Design Report Addendum
Response to RFIs

Mixed-Use Development with Infill Affordable Housing
13–17 Oxford Street and 2 Verona Street, Paddington NSW 2021

Date	Purpose
SSD Reference:	SSD-87245208
DPHI Reference:	RFI-120198738 (3 May 2026) and Addendum (7 May 2026)
CoS Reference:	R/2025/23/A (5 May 2026)
Prepared by:	Tonkin Zulaikha Greer (TZG) Architects
On behalf of:	WT Malouf, care of 17 Oxford St Pty Ltd

PROPOSED GROUND FLOOR PLAN SHOWING SURVEY LEVELS

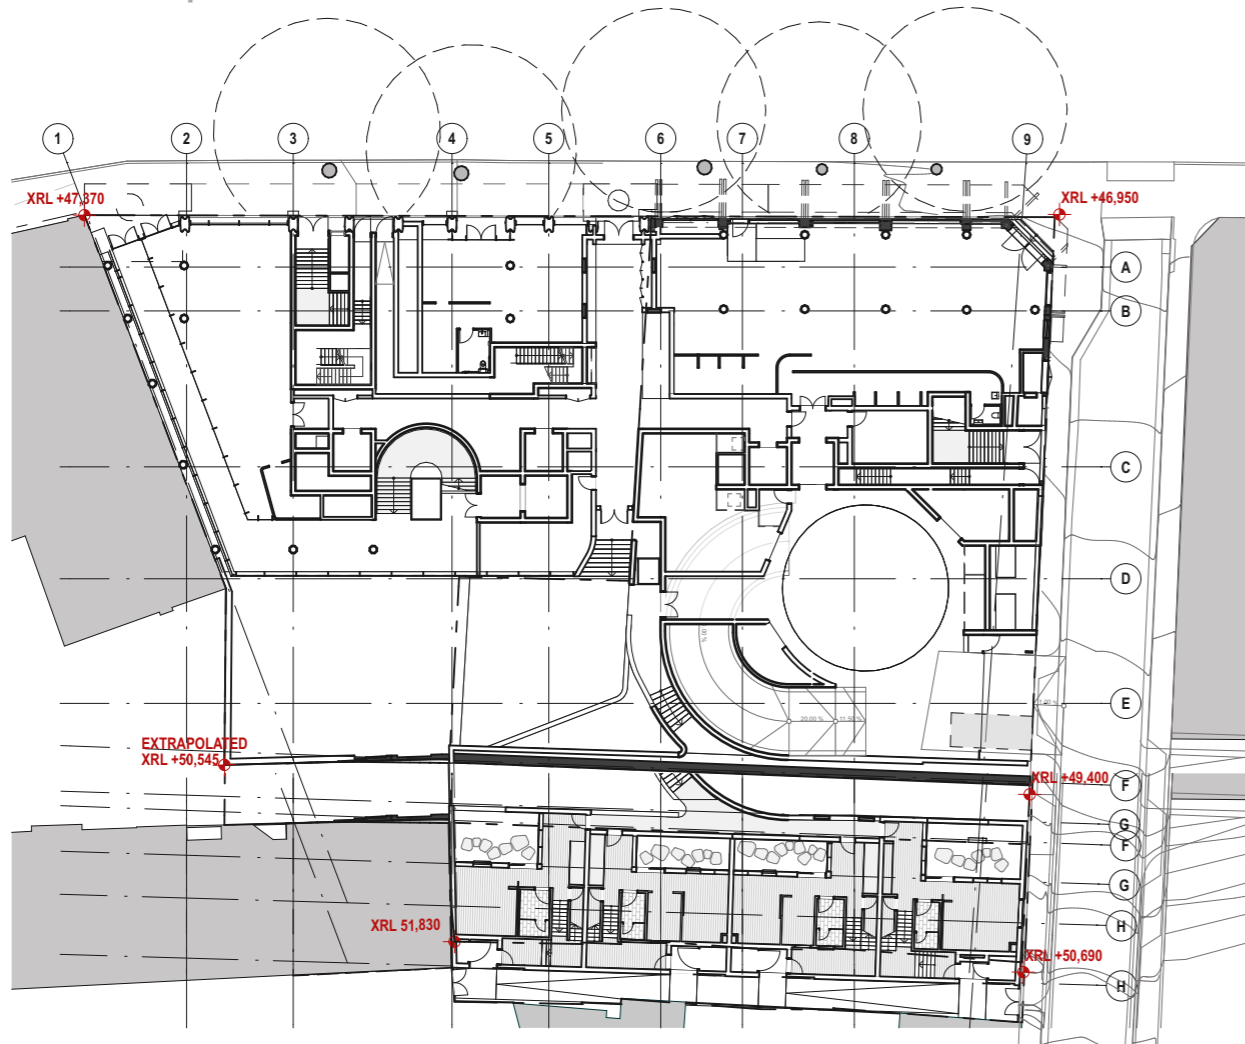
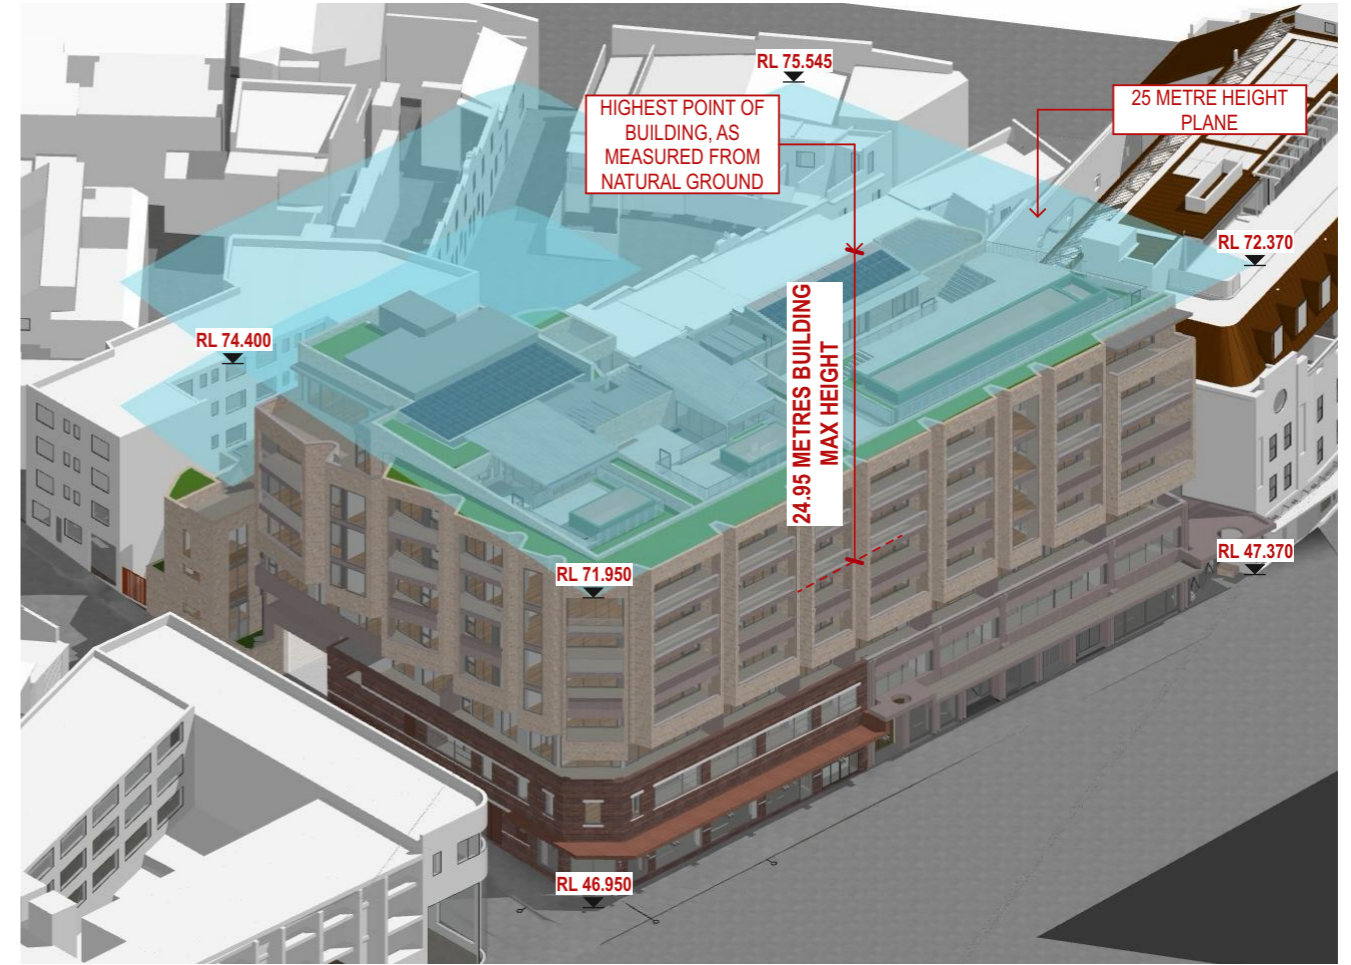
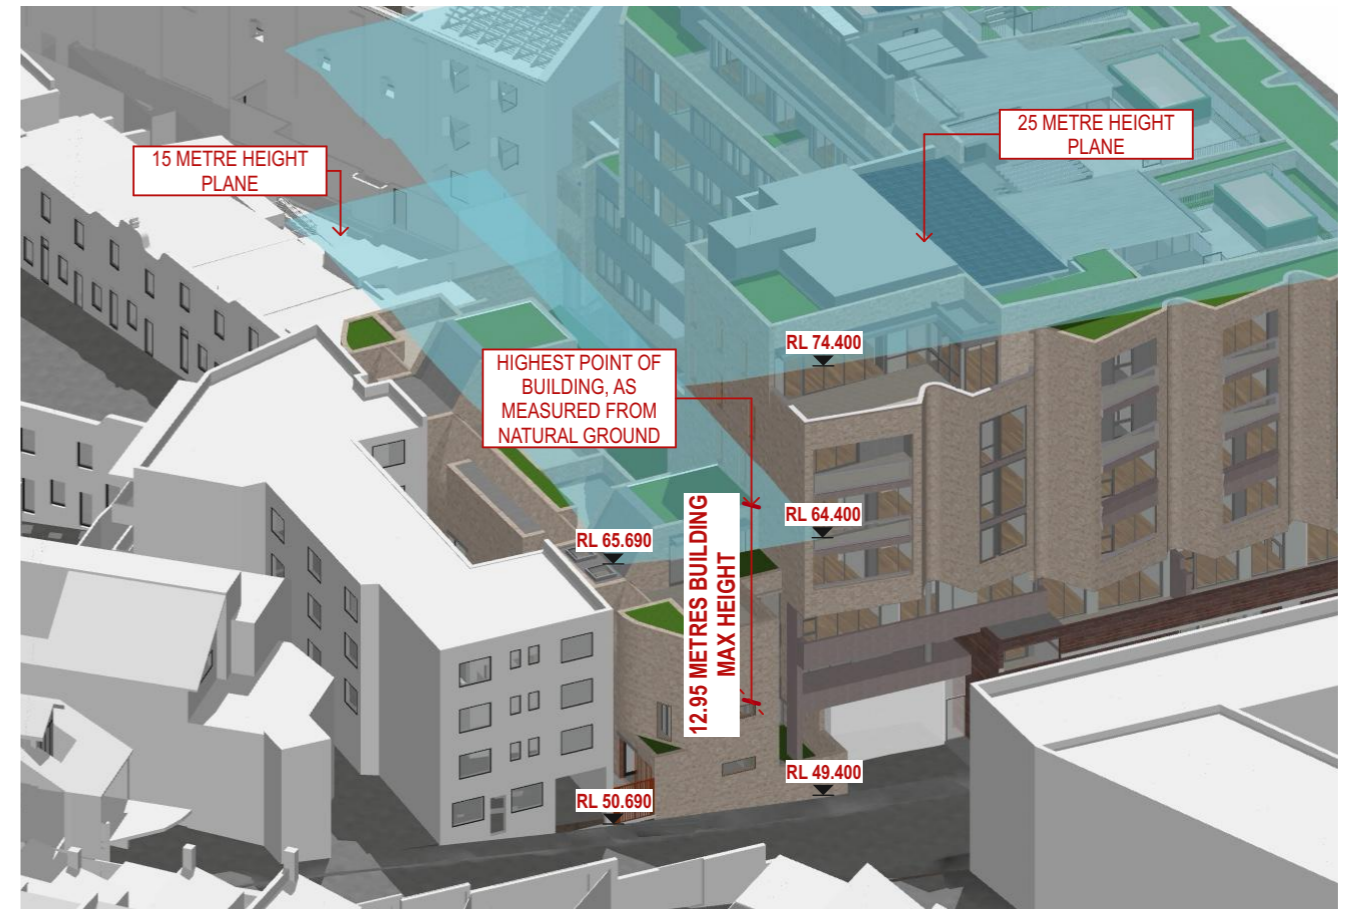
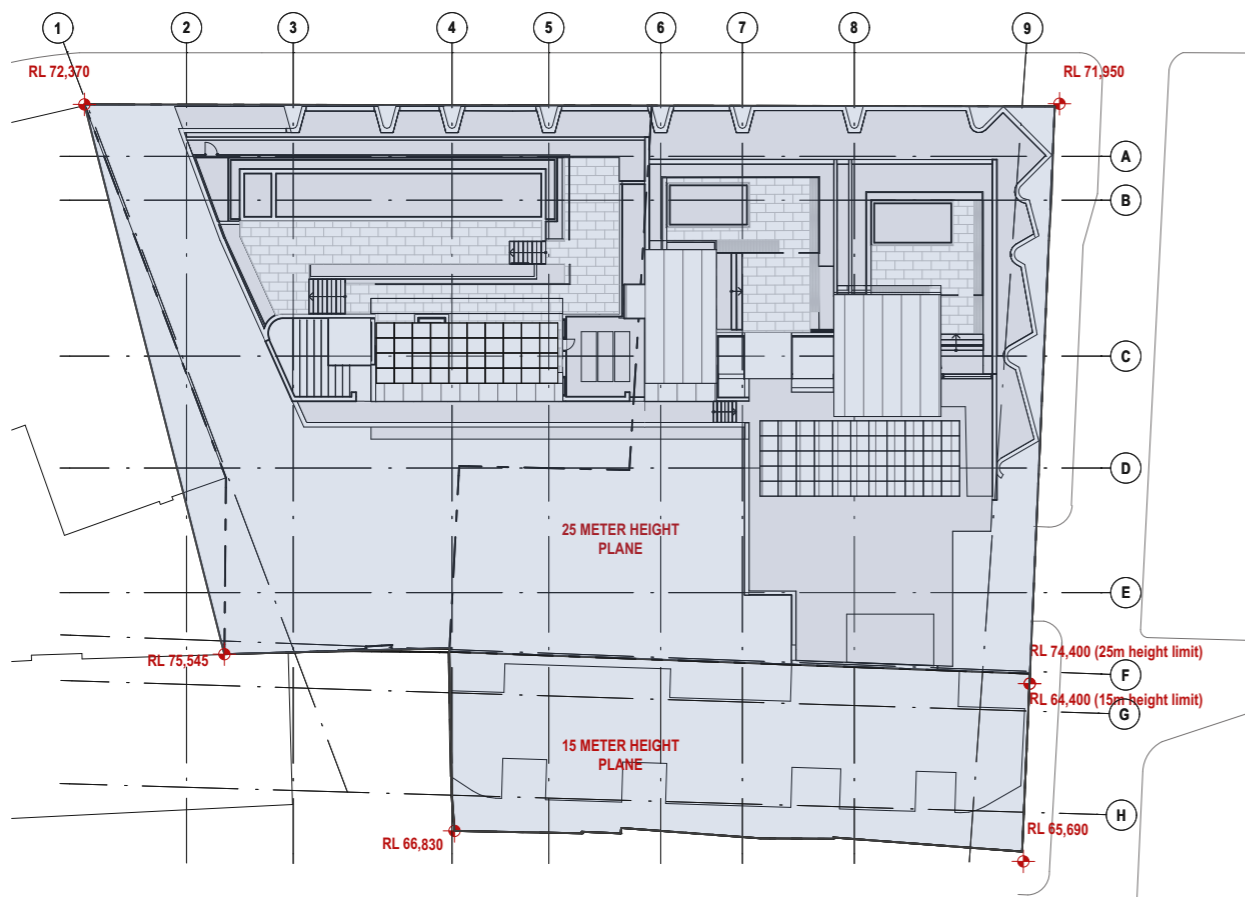
RFI 8 – Survey Levels of Existing Natural Ground	
Agency	NSW DPHI
RFI No.	8
RFI Comment	
Provide survey levels of existing natural ground on plans.	
Design Response	
<p>Survey levels of existing natural ground have been provided on the ground floor plan within the amended architectural drawing package. Existing survey levels are denoted with an "X" prefix before the relative level notation, such as "XRL". Additional survey levels have been provided on the ground floor plan for clarity.</p> <p>Survey levels are those provided by Boxall Surveyors, as issued on 16 December 2025. Proposed levels are denoted on the plans as "RL" followed by the numeric value.</p>	
Deliverables	A 100 Series - Updated Ground Floor Plan (with survey levels)

Level 1 General Arrangement Plan

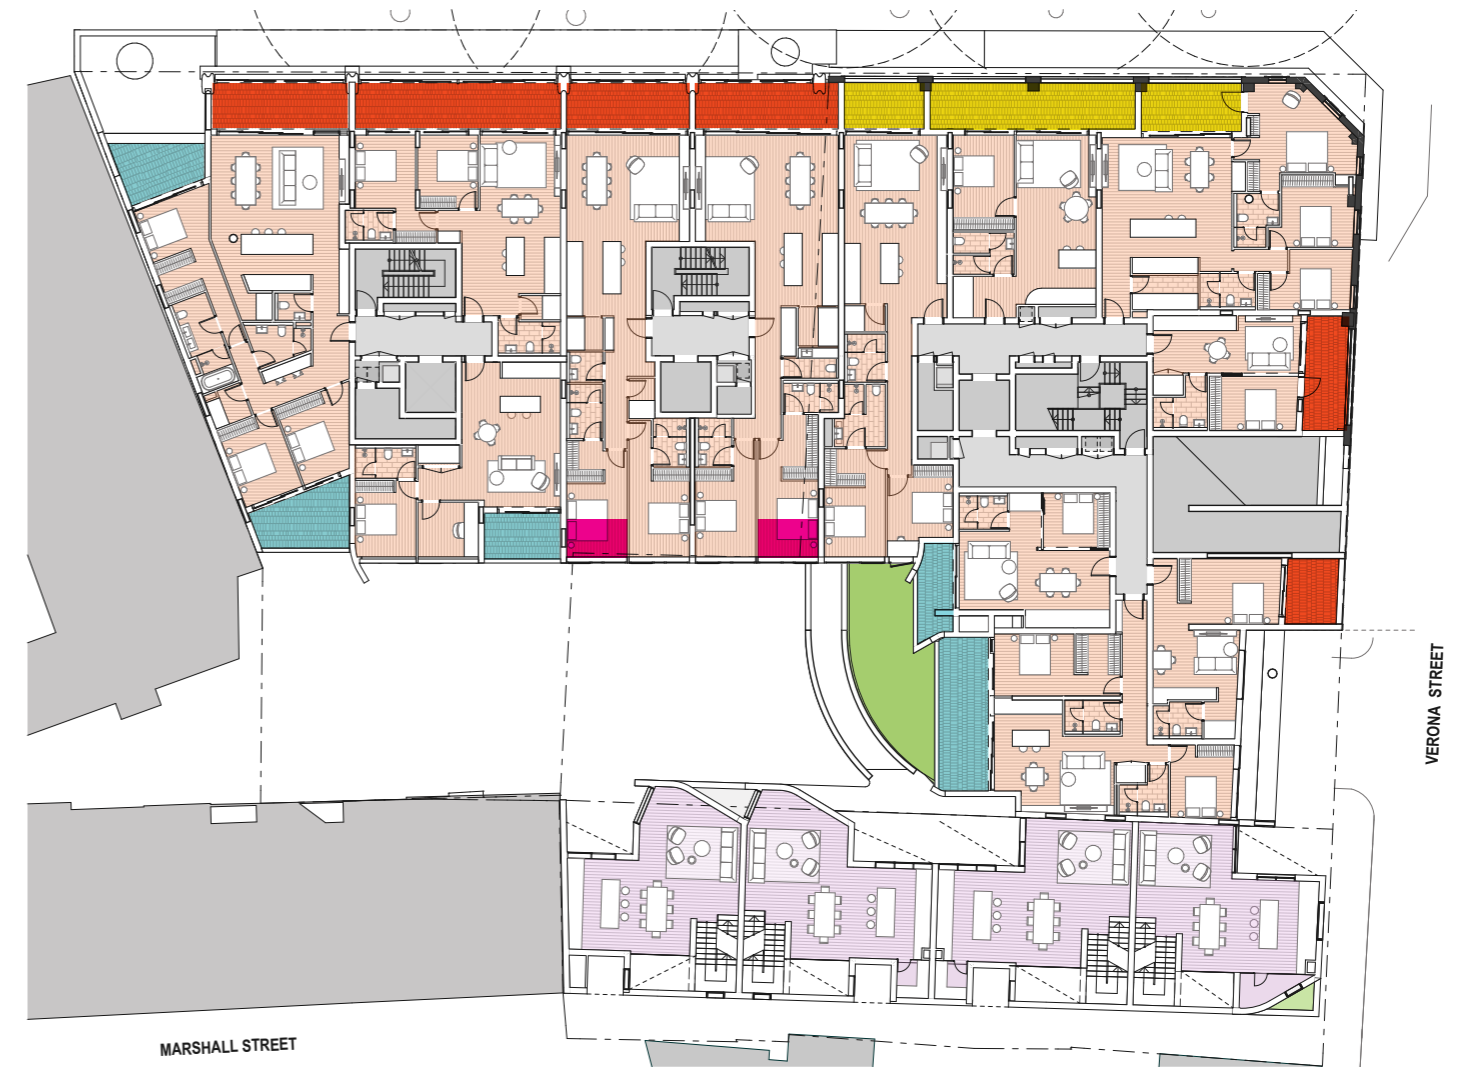
City of Sydney Letter – Affordable housing	
Agency	City of Sydney
RFI No.	Within Letter
RFI Comment	
<p>The City reiterates concern that the affordable housing apartments would have the poorest amenity of the proposed development. Most of these apartments continue to be noise-affected, without access to open balconies and 60% of the proposed affordable apartments are still not naturally cross ventilated in accordance with the ADG.</p> <p>The solar access diagrams demonstrate that the affordable housing apartments on level 1 receive solar access to the wintergarden windows, but not to living room windows, as required by the ADG. The submitted assessment includes these apartments as solar compliant, which they are not. In addition, 35% have no or limited access to direct sunlight at midwinter.</p> <p>Furthermore, it is unclear why apartments 1.13 and 1.12 have wintergardens when the market apartments above all have open balconies. The noise report confirms these apartments are not noise affected, so the City is of the view that these private open spaces should not be enclosed and should be excluded from the Affordable Housing gross floor area calculation.</p>

Design Response	
<p>Please also refer to DPHI RFI No. 2.</p> <p>A review of the Level 1 affordable housing floor plate has been undertaken, resulting in a series of design amendments that substantially improve the amenity of the affordable apartments and bring the Level 1 floor plate into closer alignment with the build-to-sell product on the levels above.</p> <p>Statutory Context</p> <p>There is no statutory requirement that the amenity of affordable housing within a mixed development be equivalent to that of market apartments. Notwithstanding this, the amended design delivers a standard of amenity that is generous in absolute terms. The affordable apartments feature floor-to-ceiling glazing, oversized private open spaces in many instances, apartment sizes that meet or exceed the market product on comparable levels, additional bathrooms in two-bedroom and larger apartments, and walk-in pantries or laundries in a number of dwellings. The affordable offering spans studios, one-bedroom, two-bedroom and three-bedroom apartments, ensuring a diverse range of household types is accommodated. Two adaptable dwellings are retained within the affordable housing component, supporting accessibility and long-term housing flexibility.</p> <p>Changes to Level 1</p> <p>The Level 1 floor plate has been redesigned to replicate the Level 2 floor plate as closely as possible, reflecting an equivalent standard of amenity to the build-to-sell product immediately above. Courtyard-facing balconies to dual-aspect apartments have been absorbed into the apartment interiors, increasing effective internal floor area. Apartments 1.01 and 1.02 have been consolidated into a single larger dual-aspect, naturally cross-ventilated apartment (now numbered 1.01), replicating the floor plan of the market apartments on the levels above. As a result of these</p>

amendments, the cross-ventilation and solar access performance of the Level 1 floor plate is only marginally different from Level 2.

Where possible, the same planning and amenity has been provided, resulting in the affordable housing product being closely comparable to the build-to-sell product. Apartments 1.01 to 1.08 are identical in planning and performance to those on the levels above. Apartments 1.09 and 1.10 differ from the level above due to the location of the OSD tank on Level 1. The configuration of apartments 1.11 and 1.12 also differs from the level above due to the head height requirements and ramp location of the loading dock below.

3D Section of Terrace House showing void and ventilation path

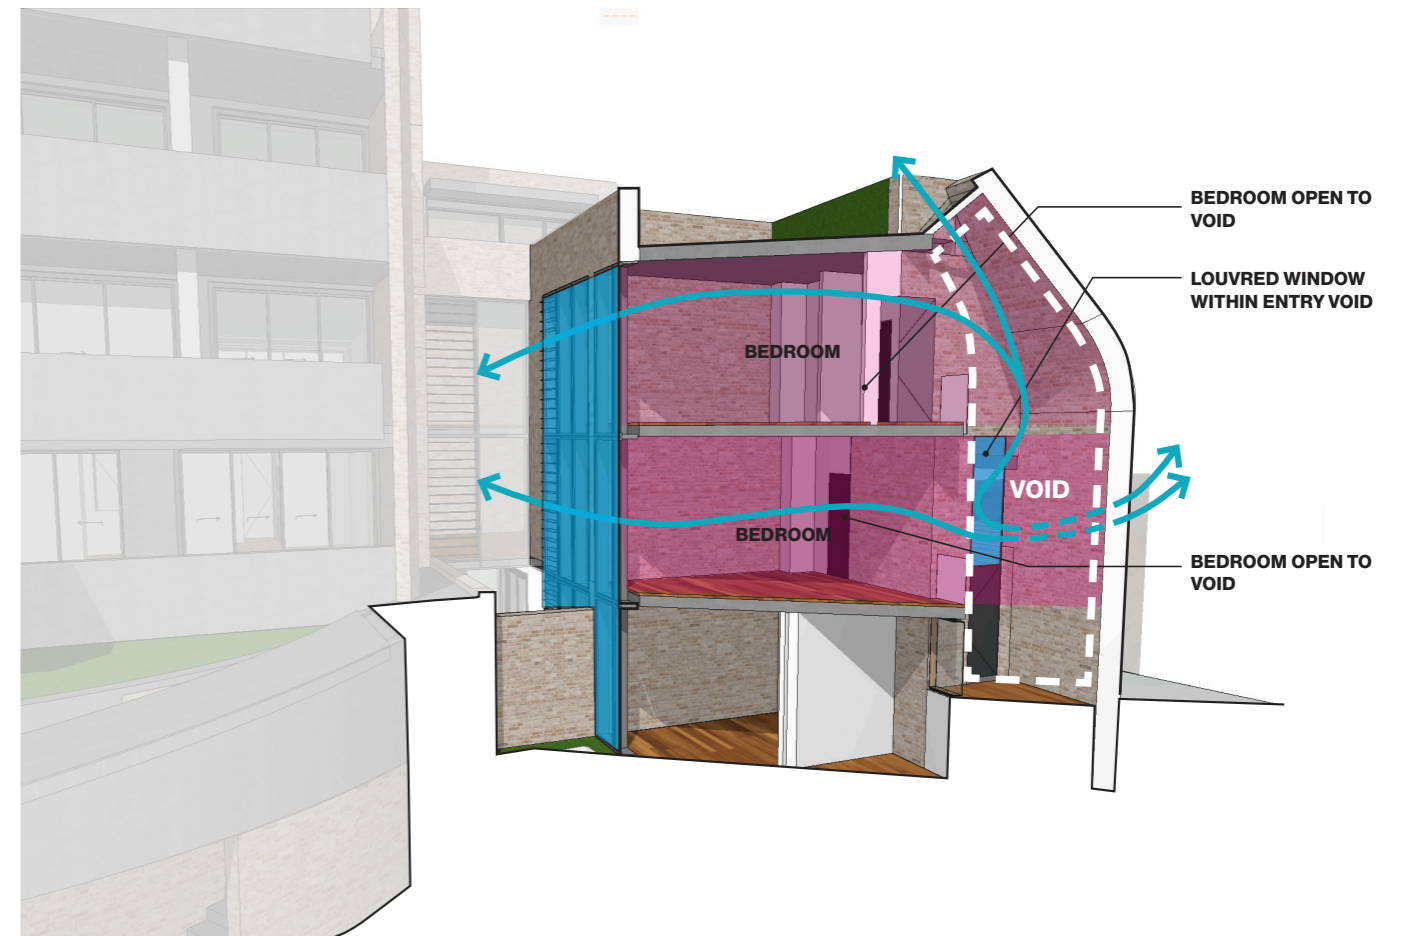
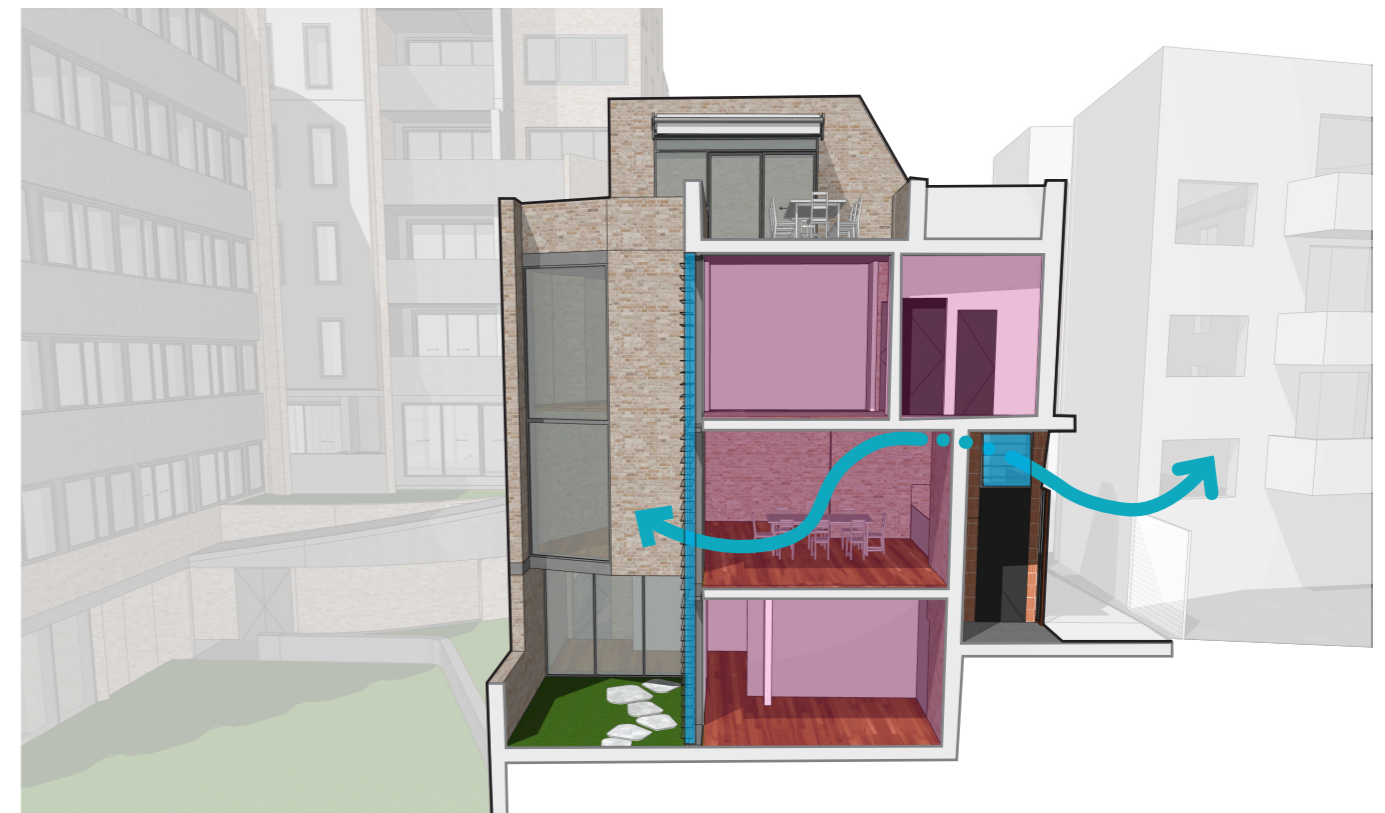
CoS Item 2 - Natural Cross Ventilation	
Agency	City of Sydney
RFI No.	2
RFI Comment	
<p>a) The City raises continued concern that the proposed development does not achieve adequate natural cross ventilation in accordance with Objective 4B-3 of the ADG.</p> <p>b) The supplied plans and elevations of terraces A, B, C and D do not clearly demonstrate the operable windows relied upon to provide cross ventilation. The supplied cross ventilation diagrams do not demonstrate that compliance is achieved.</p> <p>c) In addition, 17 apartments within the development still exceed the maximum cross-through depth of 18m from glass line to glass line. It is recommended that the depth of the building fronting Oxford Street is reduced to achieve the maximum 18m depth. This would also improve the poor amenity outcome of bedrooms facing walls in the western corner for apartments 1.13, 2.11, 3.11, 4.11, 5.09, and 6.06.</p> <p>d) There is also further scope to increase the number of dual-aspect apartments fronting Oxford Street.</p>

Design Response	
<p>a) Updated cross ventilation diagrams demonstrating compliance are included in the revised drawing package. The cross ventilation path is shown with a blue arrow, and apartments that are cross-ventilated are shown in blue, where apartments that are not cross-ventilated are shown in red. The percentage of dwellings across the development that are cross ventilated is compliant, as shown in the ADG compliance table.</p> <p>b) The cross-ventilation performance of Terraces A B and C is best demonstrated in section rather than plan. See 3D sections provided within this Design Report Addendum. Fresh air enters each terrace from the north-east courtyard elevation through floor-to-ceiling operable windows measuring 2,420 x 3,100mm (inlet area 7.50sqm). Air passes through a void within the dwelling before exhausting via operable windows of 1,000 x 1,265mm (outlet area 1.27sqm) positioned above the entry door on the south-west street elevation. The two openings are on opposing aspects of the building, satisfying the directional requirement of ADG Objective 4B-3. An operable skylight located within the void space allows air within the void space to ventilate via the stack effect. The north-east courtyard elevation receives the prevailing north-easterly to easterly sea breeze during summer afternoons, the period of greatest thermal stress and greatest benefit to occupant comfort.</p> <p>The aggregate opening area of 8.77sqm is assessed against the ADG minimum of 5% of the floor area of the habitable space served. The terrace floor area is approximately 49sqm, giving a minimum required opening area of 2.45sqm. The provided aggregate opening area of 8.77sqm represents 17.9% of floor area, exceeding the ADG requirement by a considerable margin.</p> <p>For Terrace D, fresh air enters from the north-east elevation through floor-to-ceiling operable windows of equal dimension to Terraces A-C across Ground, Level 1 and Level 2.</p>
